## **Anglian Water Services Limited – The Cambridge Waste Water Treatment Plant Relocation Project - WW010003 Additional Submission**

### **Application Ref: WW010003**

### **Note on ISH4 T&T Agenda Item 9.11**

## **Annex 2 Issues with traffic modelling in the TA Part A Note**

**Figure 2-1: Comparison of existing 2021 traffic flows at J34 in the AM peak (07:00-10:00)**

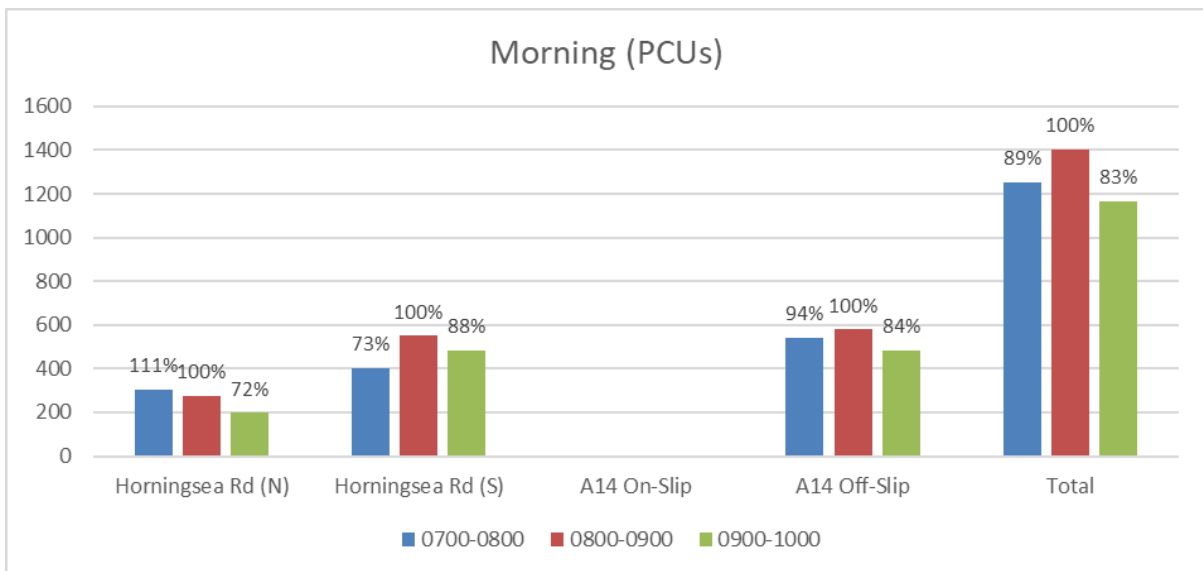
- 1.1.1 In Action Point 25 in the Action Points ISH3 [EV-007v], the Examining Authority (ExA) requested commentary for each arm of J34 to explain whether traffic during the shoulder hours during the AM and PM peak periods would exceed the threshold that was used to assess whether mitigation was needed during the peak hours assessed in the Transport Assessment Part 1 (App Doc Ref 5.4.19.3) [REP3-034] submitted at Examination Deadline 3.

- 2.1.1 The Applicant has reviewed the existing (2021) traffic flows at Junction 34 during the AM peak and PM peak periods (07:00-10:00 and 16:00-19:00) to understand the variation in the level of traffic on each arm of the junction in the shoulder hours relative to the assessed peak hours (08:00-09:00 and 17:00-18:00).
- 2.1.2 Figure 2-1 shows the variation in traffic flows (expressed in Passenger Car Units (PCUs)) on each arm of the junction and for the junction as a whole in each hour

2.1.3 This analysis demonstrates that total traffic flows (in PCUs) passing through Junction 34 in the shoulder hours are lower the total traffic flows in the assessed peak hours.

2.1.4 Focusing on individual arms, the traffic flow on Horningsea Road (N) is 11% higher between 07:00-08:00 than the traffic flow in the assessed AM peak hour (08:00-09:00), while the traffic flow on Horningsea Road (N) is 19% higher between 16:00-17:00 than the traffic flow in the assessed PM peak hour (17:00-18:00). However,

**Figure 2-2: Comparison of existing 2021 traffic flows at J34 in the PM peak (16:00-19:00)**

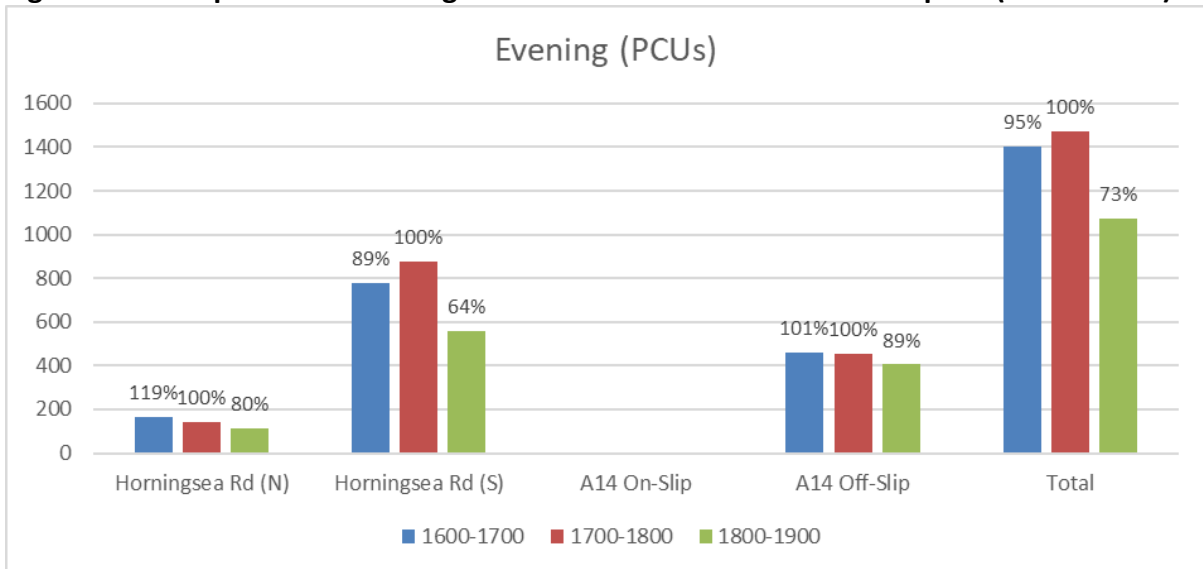
during the AM peak period (07:00-10:00). Figure 2-2 shows the variation in traffic flows on each arm of the junction and for the junction as a whole in each hour during the PM peak period (16:00-19:00). Horningsea Road (N) represents the section of Horningsea Road to the north of Junction 34. Horningsea Road (S) represents the section of Horningsea Road to the south of Junction 34.
